WELL API NO. 30-015-39515
5. Indicate Type of Lease STATE [] FEE [x]
6. State Oil & Gas Lease No.
7. Lease Name or Unit Agreement Name FALABELLA 31 FEE
8. Well Number 8H
9. OGRID Number 328947
10. Pool name or Wildcat PENASCO DRAW; SA-YESO (ASSOC)

SUNDRY NOTICES AND REPORTS ON WELLS
(DO NOT USE THIS FORM FOR PROPOSALS TO DRILL OR TO DEEPEN OR PLUG BACK TO A DIFFERENT RESERVOIR. USE "APPLICATION FOR PERMIT" (FORM C-101) FOR SUCH PROPOSALS.)
1. Type of Well: Oil Well [x] Gas Well [] Other []
2. Name of Operator SPUR ENERGY PARTNERS LLC
3. Address of Operator 9655 KATY FREEWAY, SUITE 500, HOUSTON, TX 77024
4. Well Location
Unit Letter P : 150 feet from the SOUTH line and 380 feet from the EAST line
Section 31 Township 18S Range 26E NMPM EDDY County
11. Elevation (Show whether DR, RKB, RT, GR, etc.) 3391' GR

NOTICE OF INTENTION TO:
PERFORM REMEDIAL WORK [] PLUG AND ABANDON [x]
TEMPORARILY ABANDON [] CHANGE PLANS []
PULL OR ALTER CASING [] MULTIPLE COMPL []
DOWNHOLE COMMINGLE []
CLOSED-LOOP SYSTEM []
OTHER: []
SUBSEQUENT REPORT OF:
REMEDIAL WORK [] ALTERING CASING []
COMMENCE DRILLING OPNS. [] P AND A []
CASING/CEMENT JOB []
OTHER: []
Notify OCD 24 hrs. prior to any work done [x]

Fal

Falabella 31 Fee #8H

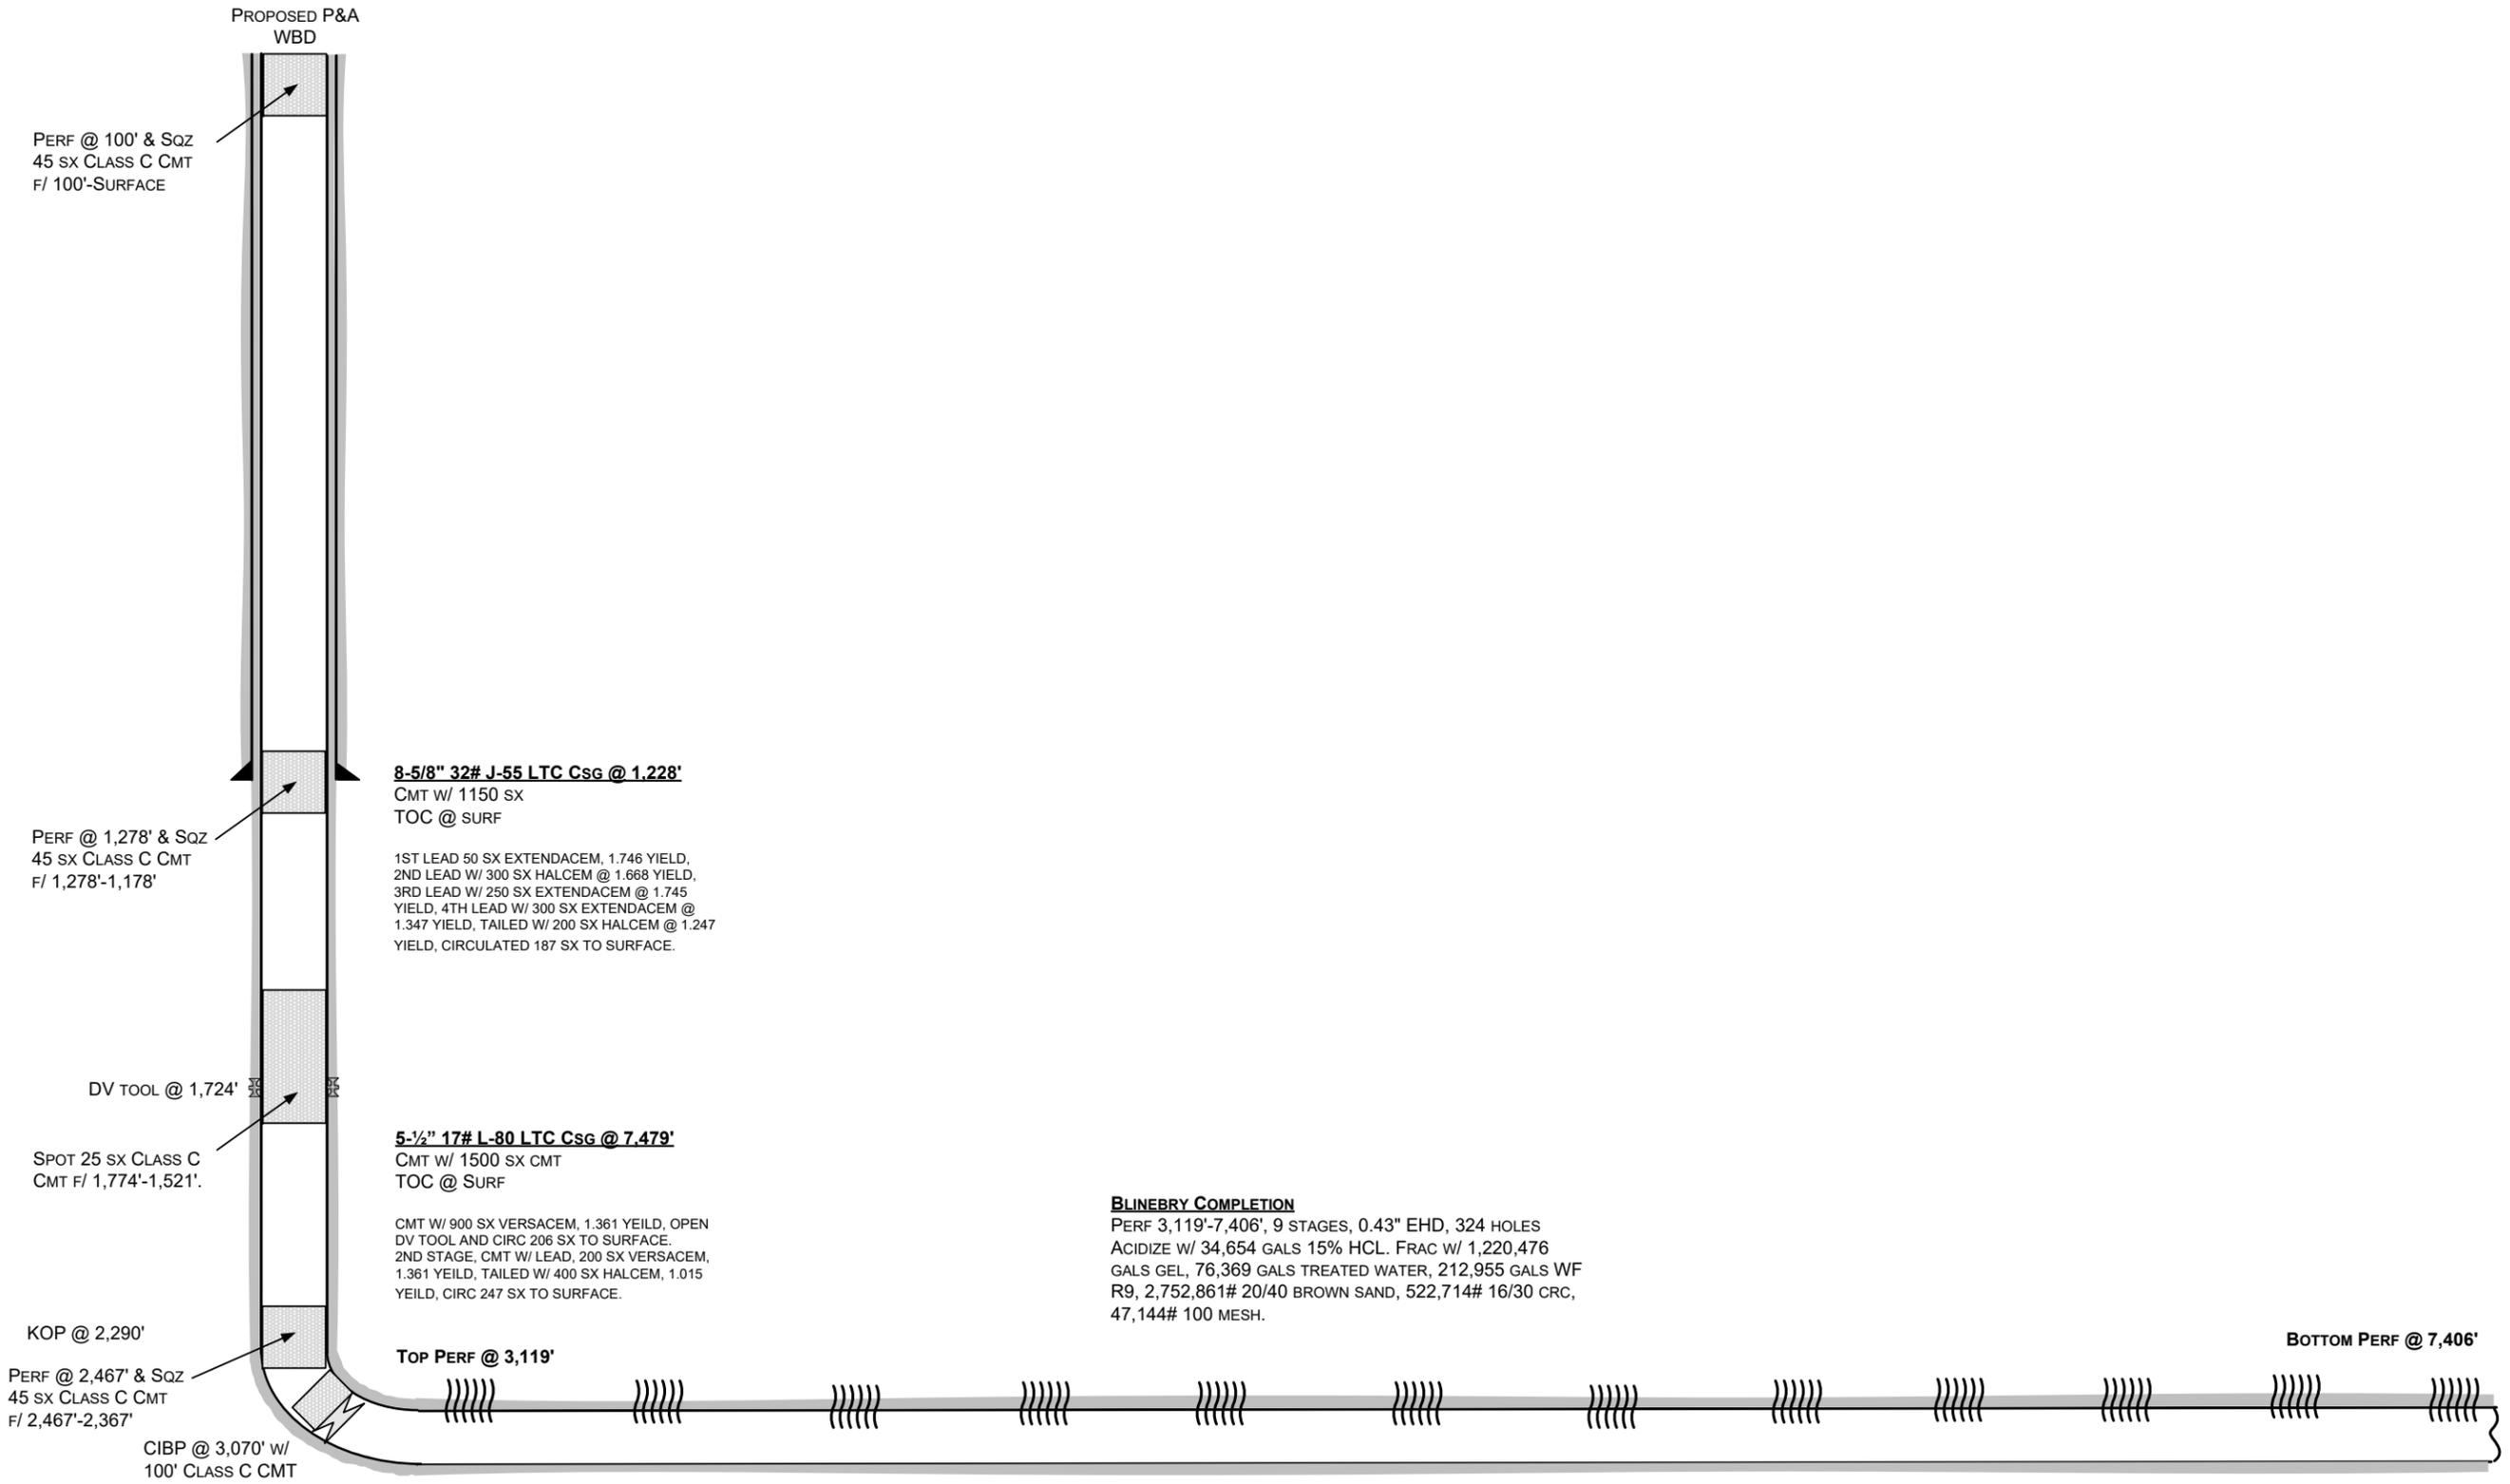
13. Describe proposed or completed operations. (Clearly state all pertinent details, and give pertinent dates, including estimated date of starting any proposed work). SEE RULE 19.15.7.14 NMAC. For Multiple Completions: Attach wellbore diagram of proposed completion or recompletion. 25 sx cmt Must Run CBL to determine TOC

Perf @ 995' & sqz 45 sx cement - WOC & tag at 895' - T. SA

Perf @ 643' & 45 sqz cement - WOC & tag at 543' - T. Grayburg
